URBAN DESIGN SPECIALIST REPORT

Date: 21.07.2020

Application: BUN60353138
223 Kohimarama Road and 9 John Rymer Place

Proposal: Comprehensive care retirement village in Residential - Mixed Housing Urban Zone

Image 1: Affected properties as identified in AEE

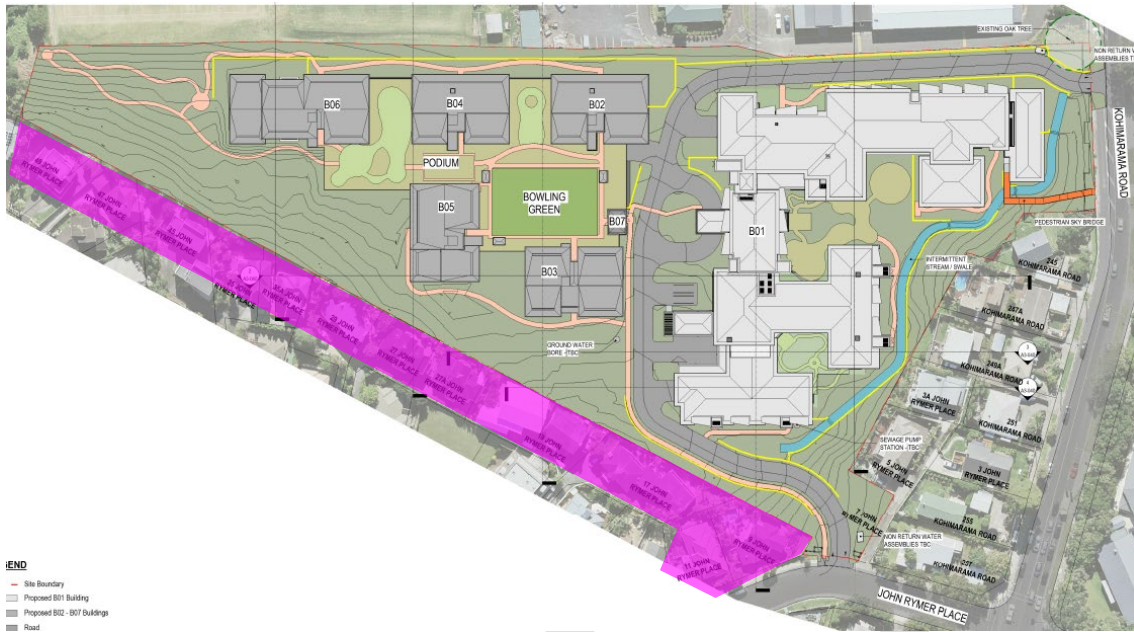
The AEE has concluded that *“the proposal will have minor adverse effects on 12 properties adjoining the southern boundary and has sought the application is processed on a limited notified basis. It has also noted that as the Ministry of Education has provided its written*

approval to the Proposed Village any potential effects associated with these infringements must be disregarded”.

Shading along the street

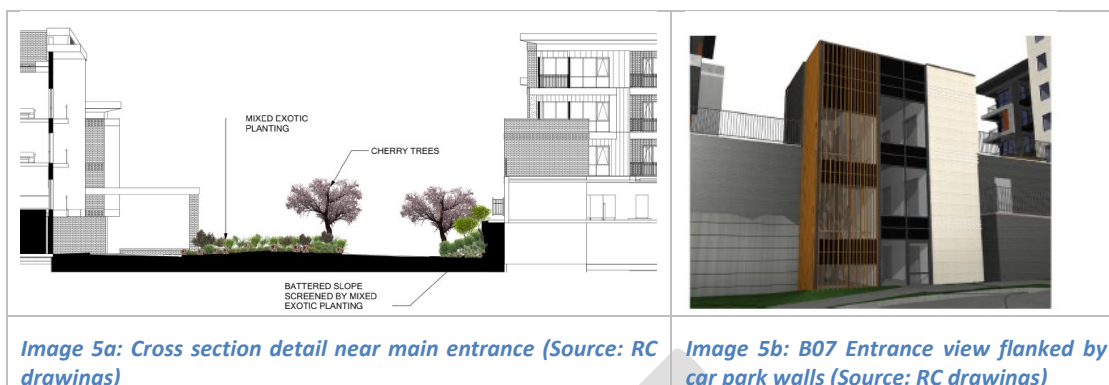
The shading analysis illustrates the extent of potential shading and privacy effects that the proposal is likely to generate over the neighbouring properties and the streets in the surrounding area.

The shading impacts to adjoining neighbours do not form part of my assessment but in terms of additional height and associated bulk, the shading studies (044-ASM-S01-A4-010 to A4-010) demonstrate that an acceptable sunny public realm could be reasonably maintained, and the additional shading does not compromise the public amenity. I also note that the proposal maintains a reasonable level of solar access to publicly accessible areas on site (the internal street and landscaped podiums).

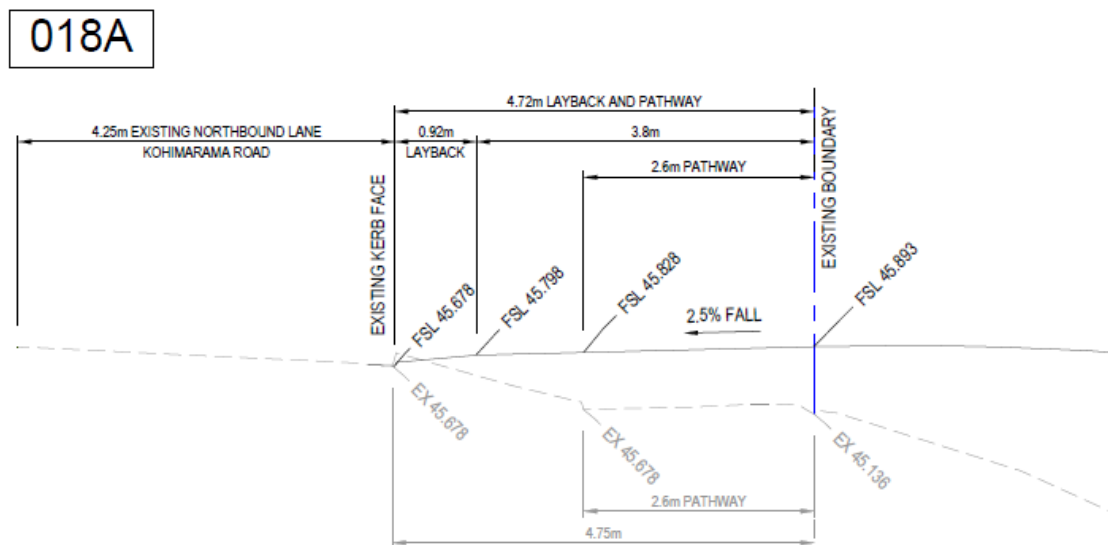
In their s92 response, the applicant confirmed that for vehicles exiting the site, the proposal is to restrict vehicles from using the northern part of the access road by placing signage directly north of the entrance to the B01 basement. This will ensure vehicles can view restrictions at the decision point and are able to divert to John Rymer Place instead.

Also, for vehicles on Kohimarama Road, the applicant confirmed that signage will be installed at the vehicle access point. The applicant's representative has offered a consent condition which is consistent with the recommendation in the traffic report:

'Permanent signage at the Kohimarama Road access shall restrict vehicle movements into and out of the Kohimarama access during school pick up and drop off periods (between the hours of 8-9am and 2:30-3:30pm) during the School year.'

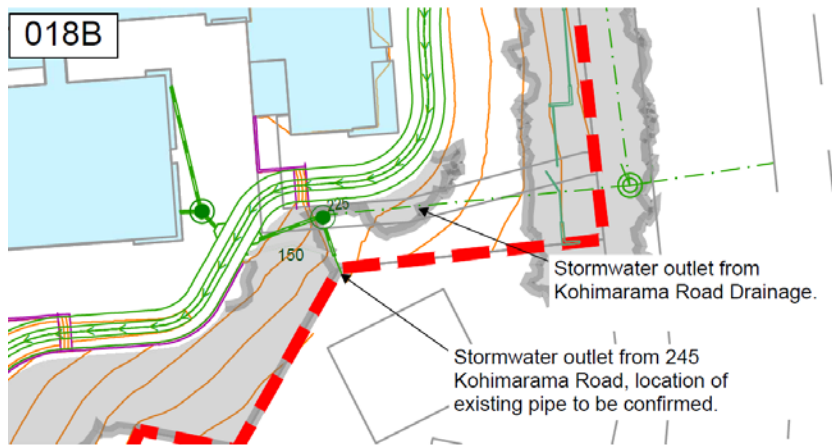
Finally, it was recommended that the access off Kohimarama Road be designed and constructed so that the primary surface flows from Kohimarama Road do not enter the site. The applicant subsequently confirmed that the levels of the vehicle crossing at Kohimarama Road will be raised to provide 200mm freeboard above the road drainage channel to prevent surface flows from entering the site (sketch 018B overleaf).

The Stormwater Specialist, upon assessment of the s92 response by the applicant, confirmed that the matters raised as part of the s92 request have been satisfactorily dealt with by the applicant.

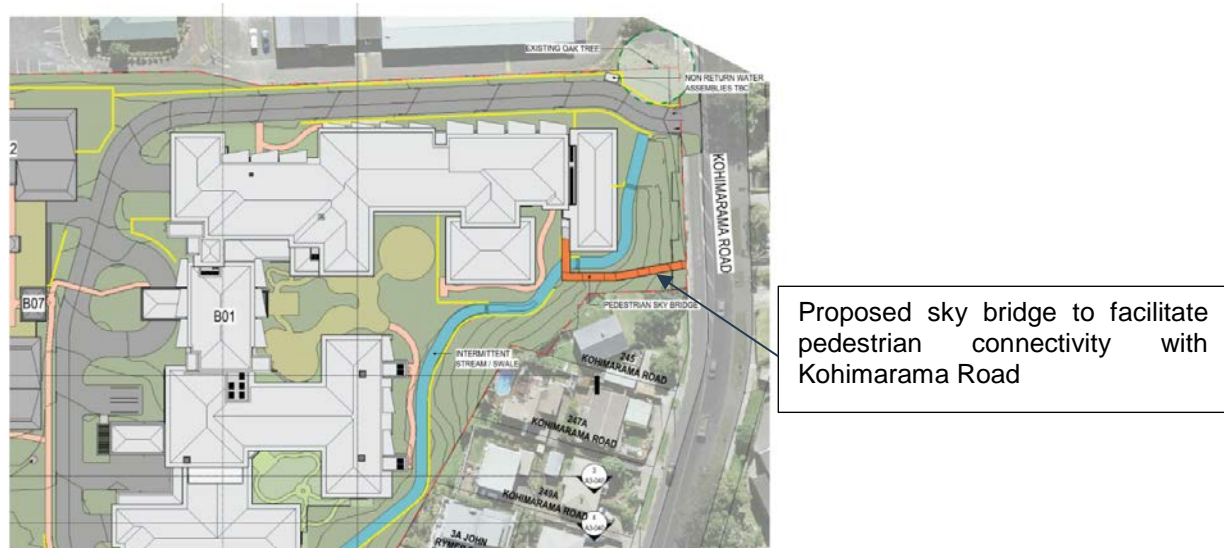
The applicant proposes a pedestrian path that would lead visitors and residents from John Rymer Place to the main entrance of Building B01, as well as pedestrian paths and boardwalks throughout the site. The pedestrian paths would also provide a series of loop walks within the site. AT's Integrated Networks Specialist raised concern around the lack of pedestrian connectivity along the "secondary" access to Kohimarama Road. This is especially so given that it is expected that most residents would want to use this access to head towards the local bus stops on Kohimarama Road. For this reason, it was recommended that appropriate footpaths be provided and that plans be amended accordingly.

In their s92 response the applicant motivated that the main pedestrian access to Kohimarama Road would be via a pedestrian sky bridge from building B01 to the southeast of the proposed vehicle access. The sky bridge is shown in orange on the image below (extract from Drawing 044-RCT-S01-010). The Specialist has noted that the sky bridge should be kept similar in width to a typical footpath in order to maximise its use and effectiveness.

Image 1: Conceptual drawing showing mussel spat rope in the weir low flow channel to provide fish passage for climbing species.

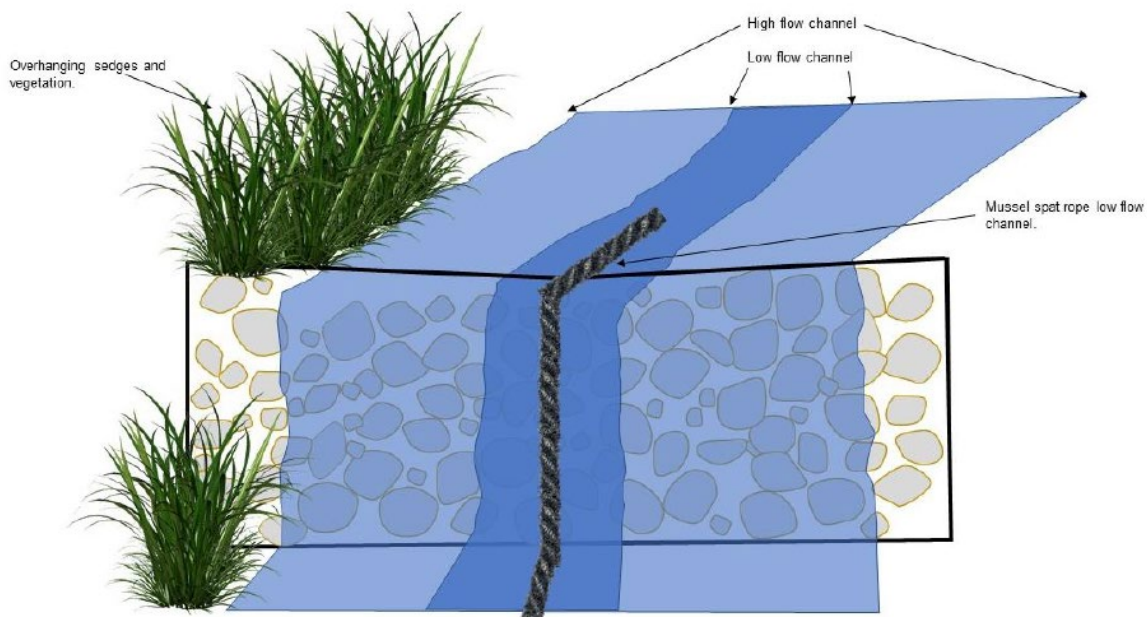
Due to a level of uncertainty when creating freshwater bodies, it is recommended that an SEV be undertaken five years following permanent diversion to ensure that the new stream achieves its predicted value to address the proposed stream loss. If it does not meet the predicted values of 0.465 for the upper section and 0.545 for the lower reach, it is recommended that a further mitigation plan be provided to Council for approval so that further works can be undertaken in order to ensure that the SEV of the new channel meets the predicted values for each reach. Recommendations to this effect have therefore been included below.

Image 3: Indicative habitat creation in new channel & horizontal realignment.

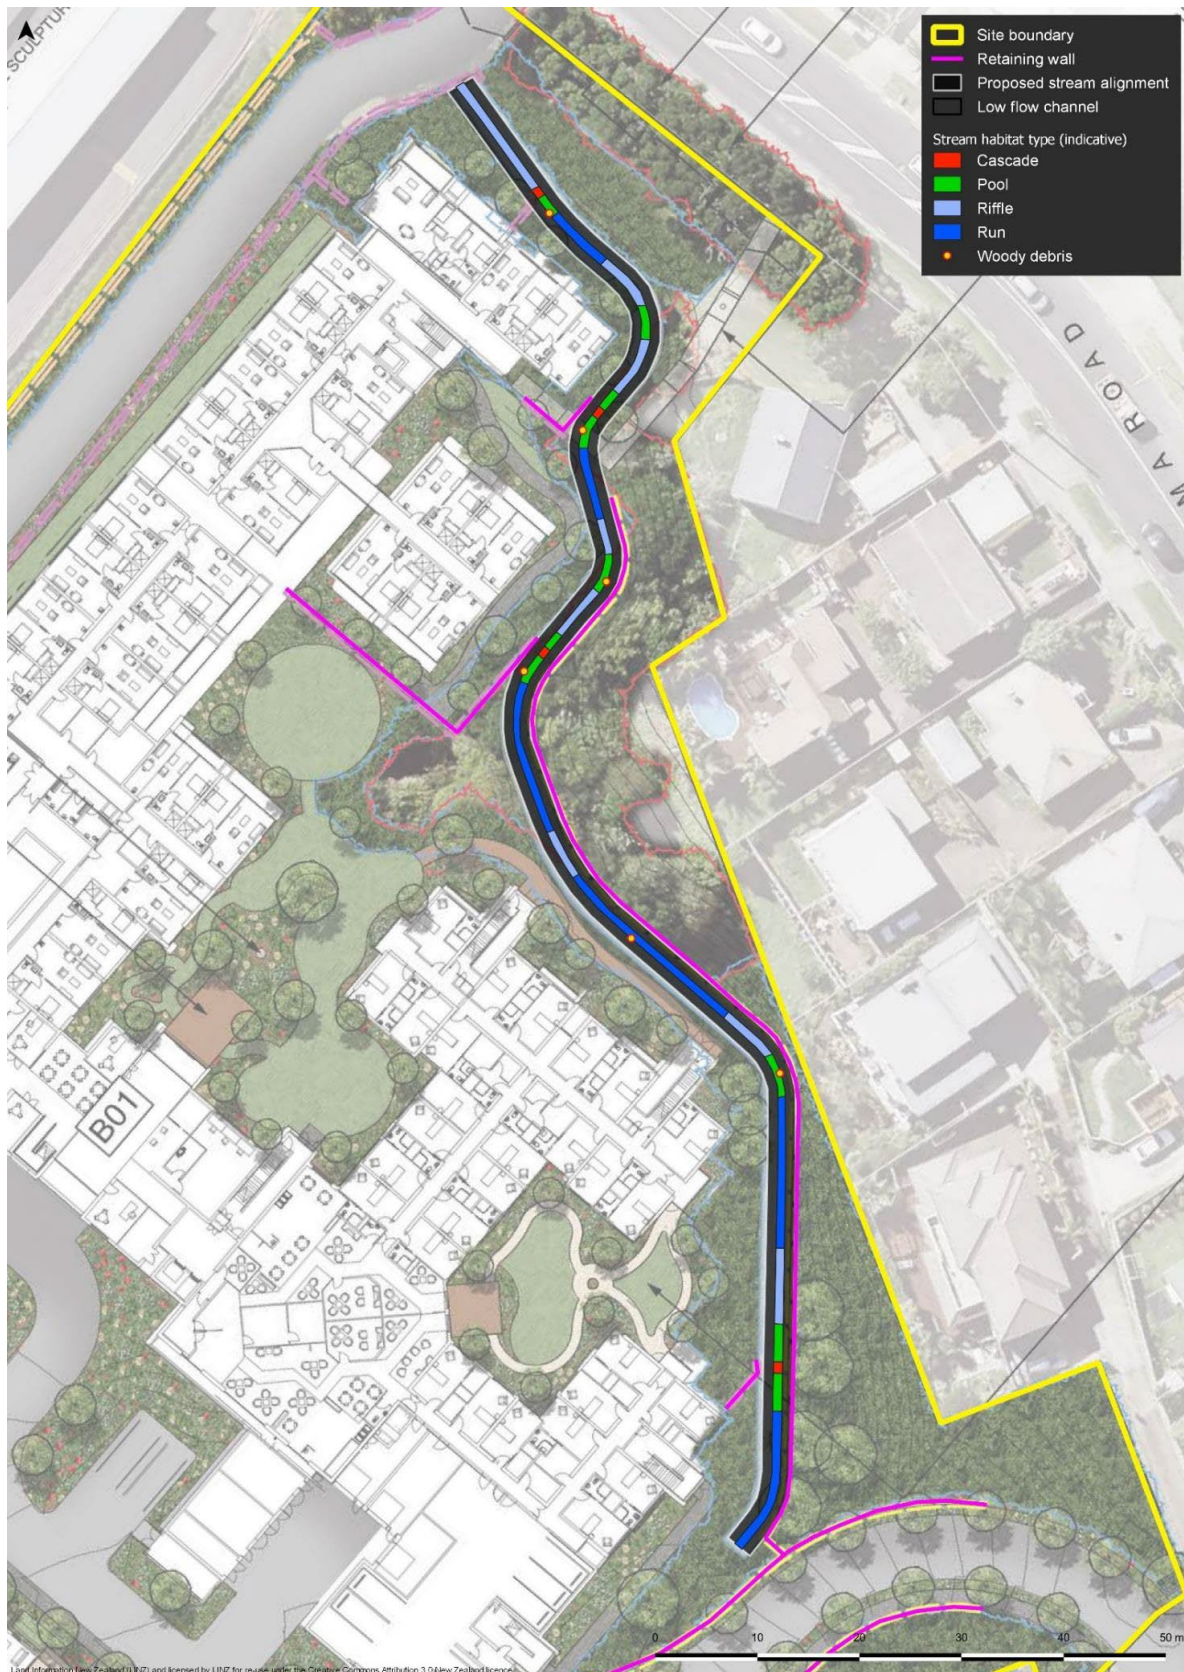
Image 2: Cross section showing indicative riparian planting along new stream (note: example of retaining wall on left bank).

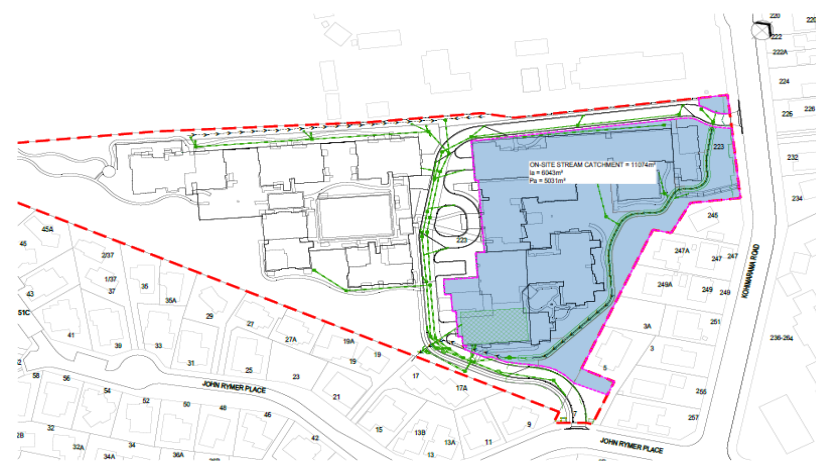
The applicant's consultant (Beca) estimated that the stormwater runoff from 61% of the site's sheet flows to the existing stream located within the site. Discharges are then piped to the stormwater network system via a 450mm diameter pipe and a 225mm diameter pipe from two hollows located on-site. Runoff from the remainder of the site discharges as sheet flow into the rear of the lots along the south eastern boundary at 17 to 47 John Rymer Place.

The two hollows on the Ryman site currently provide an informal form of peak flow attenuation, reducing downstream flow rates relative to the incoming upstream flow.
